MEMORANDUM

REVIEW TYPE: Pre-Preliminary Plan Review per Section 50-33 for Planning Board advice only

PROJECT NAME: Anselmo Property

CASE #: 720080240

PRE-APPLICATION CONCEPT PLAN
ANSELMO PROPERTY
 COLEVILLE ELECTRON DISTRICT #5
 MONTGOMERY COUNTY, MARYLAND

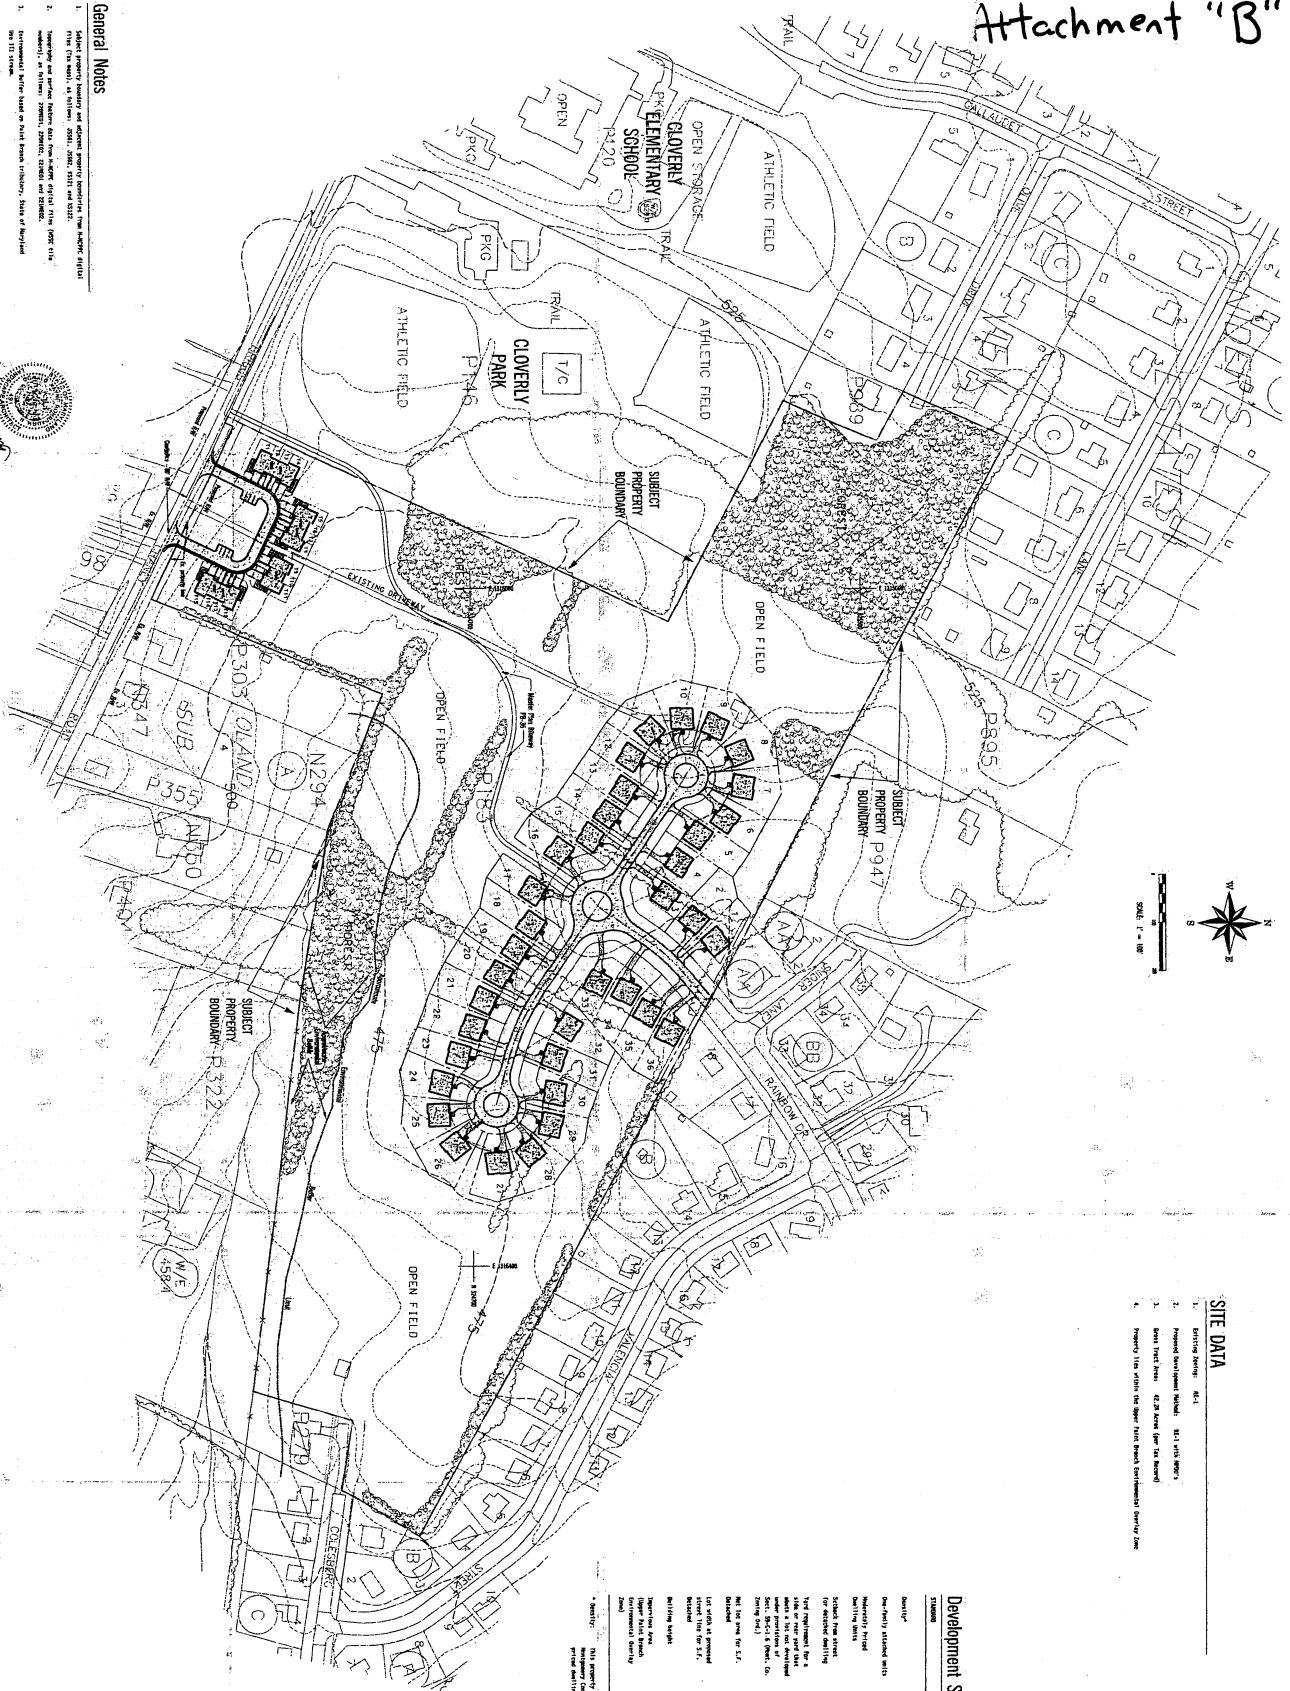
The submitted plan proposes to extend Rainbow Drive for a short distance onto the Subject Property, where it will then split into two cul-de-sacs. The right-of-way for the road would also be down-graded from a 60-foot primary road to a 50' tertiary road. Thus, Rainbow Drive will essentially become one long, overlength cul-de-sac. In staff's opinion, such a road configuration should not be permitted because there is a logical alternative that provides interconnection with another existing road and another point of access for the proposed units.

In this instance, staff cannot make a finding that this property is of unusual shape, size or topography and that a cul-de-sac would produce an improved street layout. The Property is relatively flat and is not of such small size as to prohibit a second street connection. Nor is it so large that a through street would result in unnecessary pavement. Because of the cluster nature of the lots that both staff and the applicant support, a double loaded, through-street appears not only feasible, but also efficient. Staff finds that the existing conditions of the Property do not warrant a Planning Board finding to approve a cul-de-sac of more than 500 feet for the Property.

Since the possibility of connecting Rainbow Drive to Briggs Chaney is not supported by the master plan, staff believes that Rainbow Drive will need to be completed as a secondary residential street from its current terminus at the northern boundary of the property to the existing Colesberg Street stub on the eastern boundary of the Property. (See attachment D) The applicant points out that this is not a master planned road connection; however, the Planning Board has the authority to coordinate roads within subdivisions with other existing, planned or platted roads. The existing street alignment of Colesberg Street where it terminates at the site leaves no doubt in staff's mind that it was always intended to extend onto the Subject Property. This connection will not provide the same benefit that a connection to Briggs Chaney would, but it will provide two points of access to the proposed subdivision as well as complete Rainbow Drive as a through street.. Staff places considerable weight on this recommendation; providing more than one vehicular access point to subdivisions of this size for safety and efficiency of movement is very important. As one can conclude, the applicant's proposal for two cul-de-sacs would provide no such access.

The applicant contends that locating the townhomes within walking distance to mass transit, the park, school and shopping area is appropriate. Staff believes that the entire site is within walking distance of these local amenities and that with the construction of hiker/biker trails from the Briggs Chaney sidewalk to the newly constructed Rainbow Drive/Colesberg Street connection, this will be a walkable community. Therefore, from an accessibility standpoint, there is no significant advantage in locating units along Briggs Chaney Road. In staff's opinion, all proposed lots should be clustered together in the northern half of the Property served by the new roads. With such a layout, staff believes this option would actually be more advantageous from an impervious surface standpoint and would provide more contiguous open space. In staff's opinion, placement of townhomes along Briggs Chaney Road is also out of character with the current lot pattern which consists of large one-family detached residential lots. Therefore, staff recommends that all future development be located north of the existing onsite stream valley.

With respect to the location of stormwater management facilities, staff notes that the current plan shows no such facilities, however, it would be expected for any stormwater feature to be located on the north side of the stream valley adjacent to the streets and homesites. Staff would support minimizing grading for any stormwater management facility.

As shown in the Cloverly Master Plan, staff supports a bikepath connection from Rainbow Drive south to the bikepath on Briggs Chaney Road, where users can access public transportation, the Park, school and shopping. Staff suggests using the alignment of the existing driveway to the existing house on the property for this bikepath. A direct connection to Cloverly Park as proposed by the applicant and shown on the current pre-preliminary plan is not advisable since it terminates near an active ballfield in the Park and does not connect users to an existing sidewalk. The path alignment recommended by staff will serve as a better connection and be safer than the applicant's alternative.

As mentioned above, the Property is located in the Upper Paint Branch Environmental Overlay Zone where imperviousness limitations are set at 8% over the site. This is a restrictive cap for imperviousness with a goal of maintaining the good water quality that the Upper Paint Branch system currently exhibits. The applicant has proposed pervious surfaces for some of the sidewalks, paths and driveways and has asked the Planning Board, in light of their recent discussions with staff, to exclude the pervious pavement from their impervious limits.

Although porous pavement materials can be considered useful to fulfill certain stormwater management goals for water quality by MCDPS, staff and the Planning Board have historically not allowed them to be considered pervious because of their unknown long-term effectiveness. The Board has expressed interest in further research, but until a change in policy is recommended, staff recommends that the Board continue to calculate impervious coverage as they have historically done, i.e., no credit for porous pavements. If the applicant is concerned about meeting the 8% impervious cap with either their proposed layout or that proposed by staff, they should consider smaller house footprints and shorter and/or shared driveways.

Sidewalks are important because, as staff has suggested, this is a walkable community in close proximity to a number of public and private amenities. Given the clear intent of the master plan to provide a bikepath through this site to connect to the bikepath on Briggs Chaney Road, staff recommends a 5 foot wide sidewalk on the north side only of the new street connection so that it can be connected to the existing sidewalk on the north side of Colesberg Street and to the recommended bikepath.

ANSELMO PROPERTY (720080240) * Illustrative Only

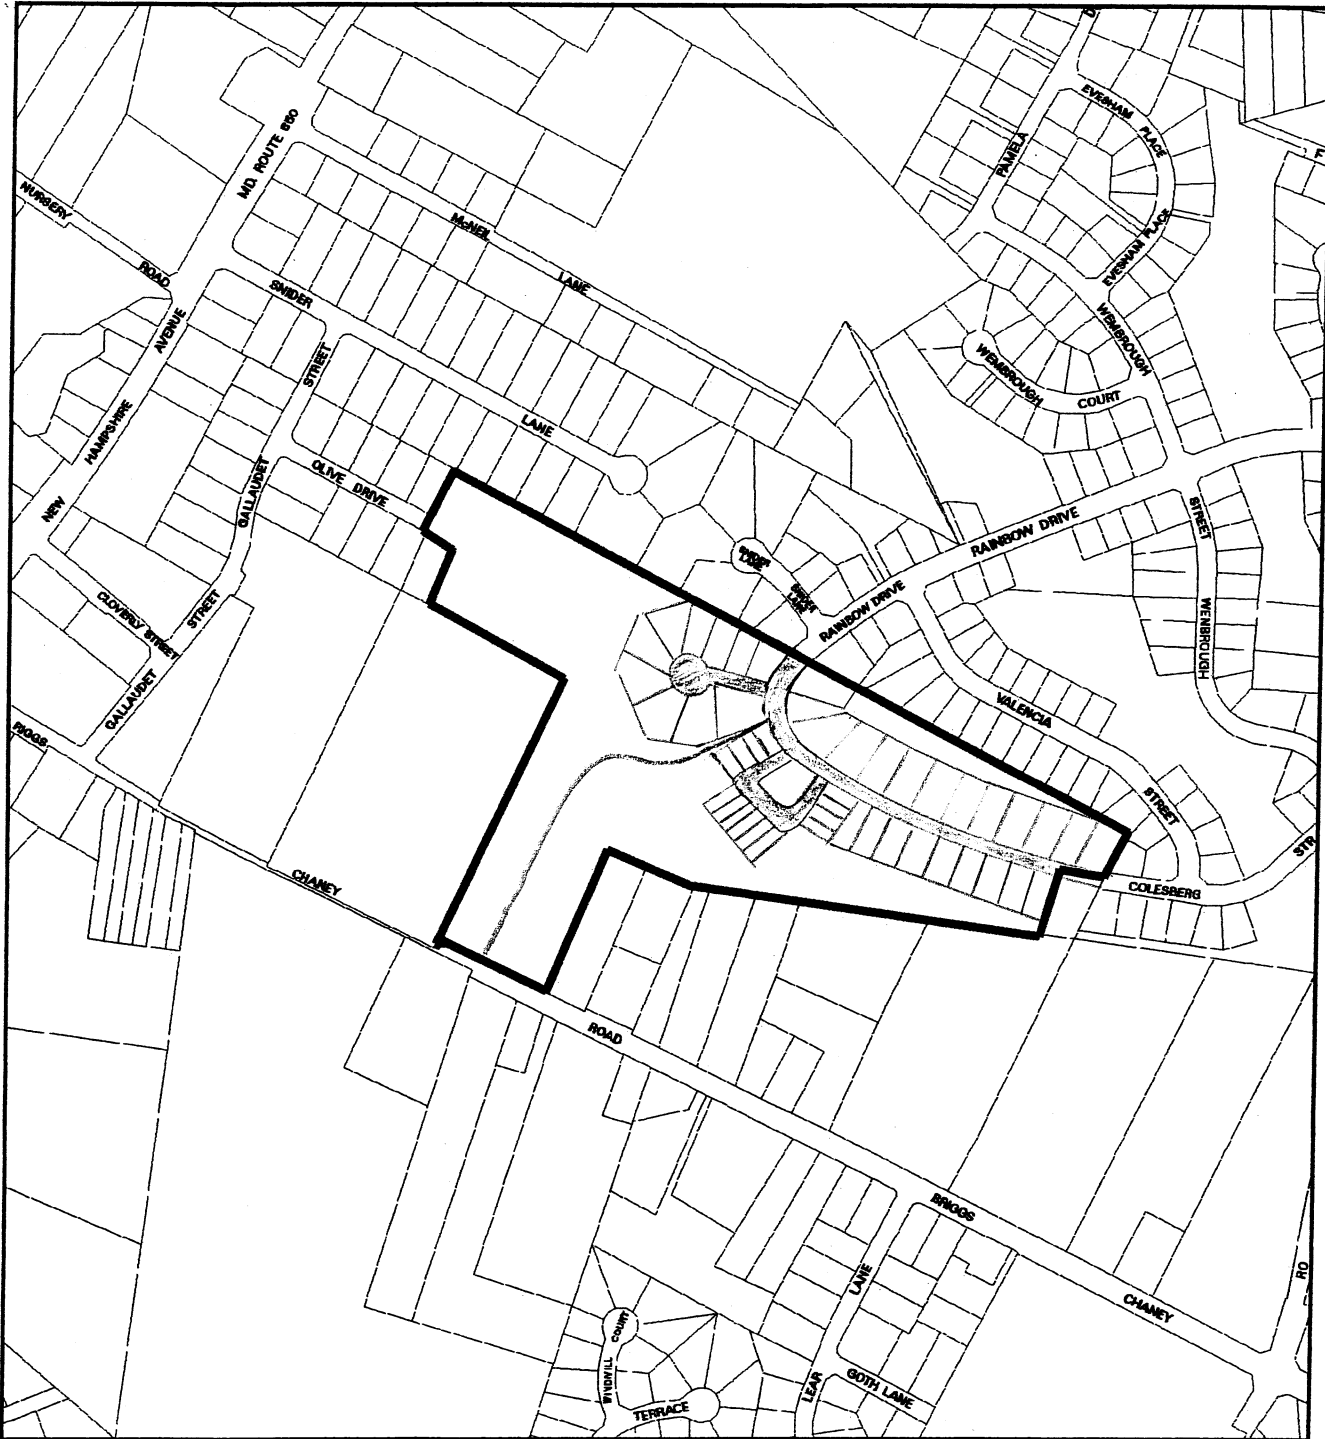
The connection to Colesberg Street will involve obtaining right-of-way from one existing property owner at the terminus of Colesberg Street (Parcel 279) so that the right-of-way can be complete. Staff believes that the Applicant must make a good faith offer to acquire the required right-of-way from that property owner. Staff understands that the deed for the parcel on which this house sits was worded to indicate the intention that Colesberg Street would one day be connected through the parcel; the deed for the parcel establishes a public utility easement in the exact location where it would be established on a record plat if this dedication is completed. Staff also understands that the owner of this intervening property is the daughter of the owner of the Subject property.
